STATE OF CONNECTICUT  
CONNECTICUT SITING COUNCIL

IN RE: :  
 :  
APPLICATION OF CELLCO PARTNERSHIP : DOCKET NO. 455  
D/B/A VERIZON WIRELESS FOR A :  
CERTIFICATE OF ENVIRONMENTAL :  
COMPATIBILITY AND PUBLIC NEED FOR :  
THE CONSTRUCTION OF A WIRELESS :  
TELECOMMUNICATIONS FACILITY AT 99 :  
EAST STREET, SOUTHLINGTON, :  
CONNECTICUT : FEBRUARY 13, 2015

**RESPONSES OF CELLCO PARTNERSHIP  
D/B/A VERIZON WIRELESS TO CONNECTICUT  
SITING COUNCIL PRE-HEARING INTERROGATORIES, SET ONE**

Coverage is depicted at a signal threshold of 120 dB Operational Path Loss

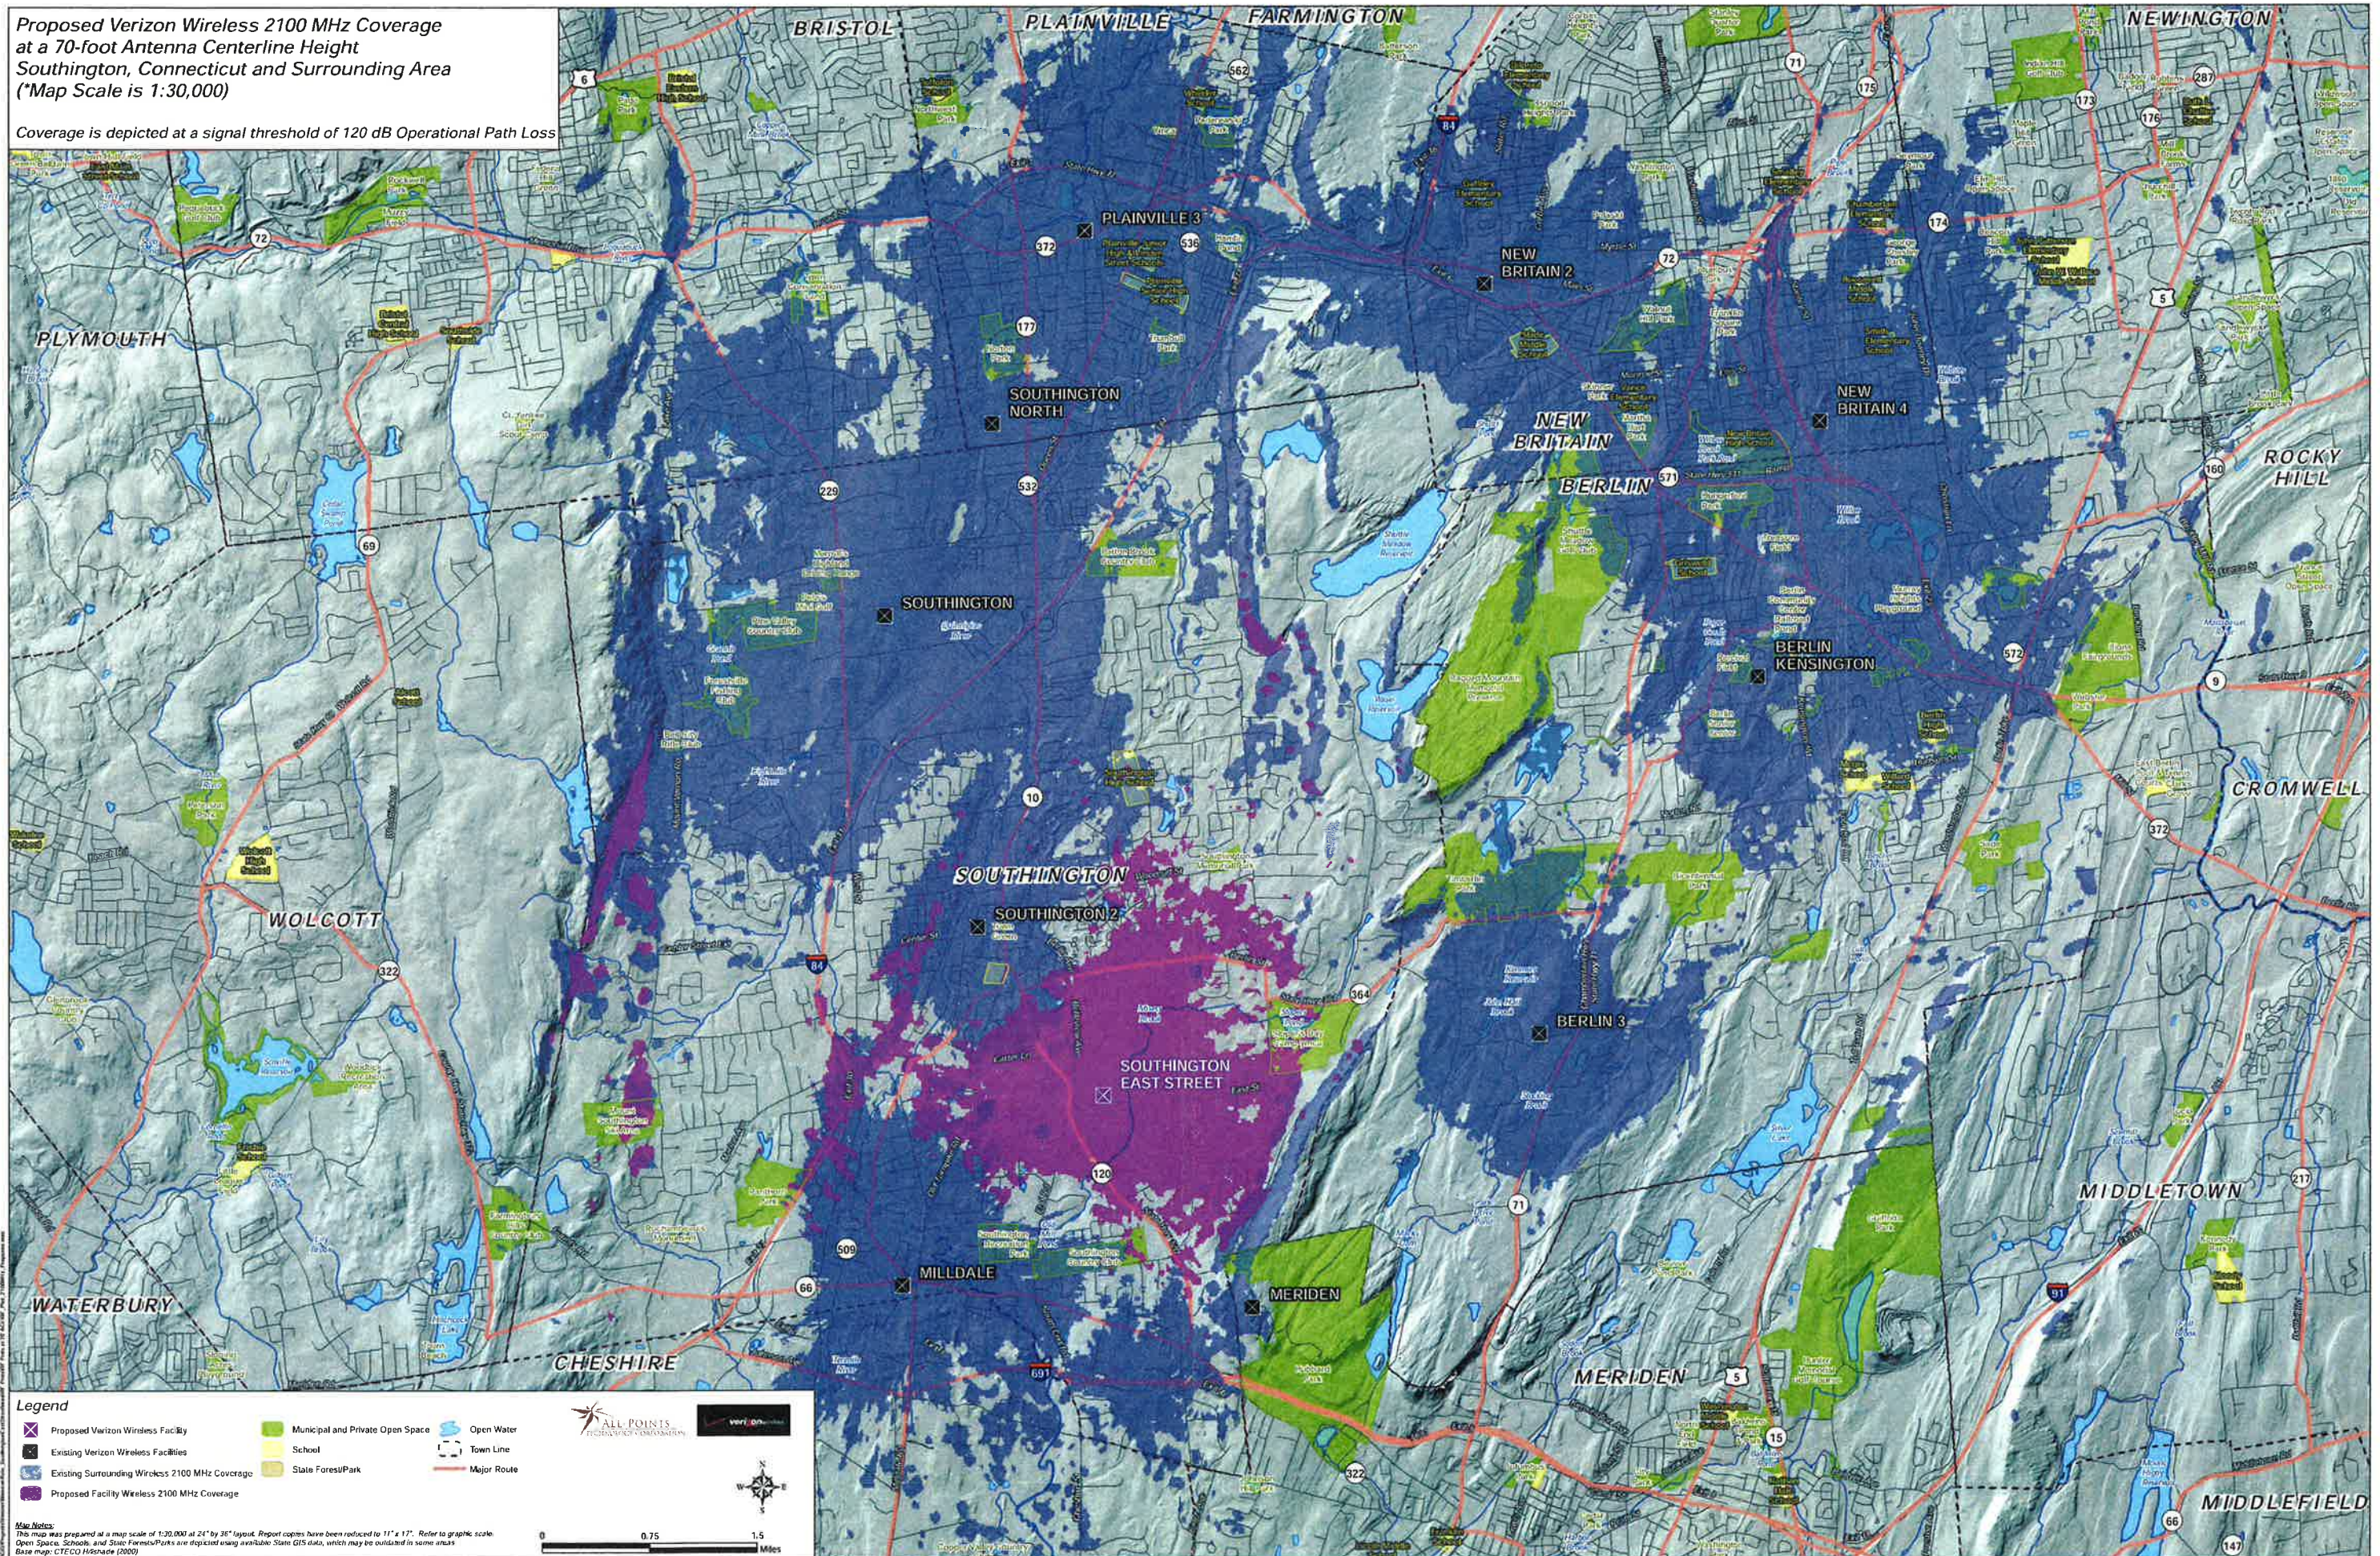
What is the lowest height at which Cellco's antennas could achieve its coverage objectives at the proposed site? What problems would Cellco experience with antennas below this height? Submit propagation maps showing the coverage at ten feet below this height.

After analyzing this location, Cellco's RF Engineers have determined that an 80-foot antenna height is, in fact, the lowest height at which Cellco can satisfy its wireless service objectives. Lowering the antennas to a centerline height of 70 feet above ground level ("AGL") would have a significant impact on coverage from this site, particularly to the north, east and southeast due to its proximity of mature trees (some between 70 and 80 feet tall) that surround the cell site and the larger Town-owned parcel, generally. At 70 feet AGL, the coverage footprint from the site would shrink from 11.92 square miles (at 80 feet AGL) to 10.86 square miles at 700 MHz frequencies; 13.3 square miles (at 80 feet AGL) to 12.40 square miles at 850 MHz frequencies; 7.3 square miles (at 80 feet AGL) to 6.78 square miles at 1900 MHz frequencies; and 5.63 square miles (at 80 feet AGL) to 5.14 square miles at 2100 MHz frequencies. Plots showing Cellco's wireless service at an antenna height of 70 feet AGL are included in Attachment 1 of these responses.
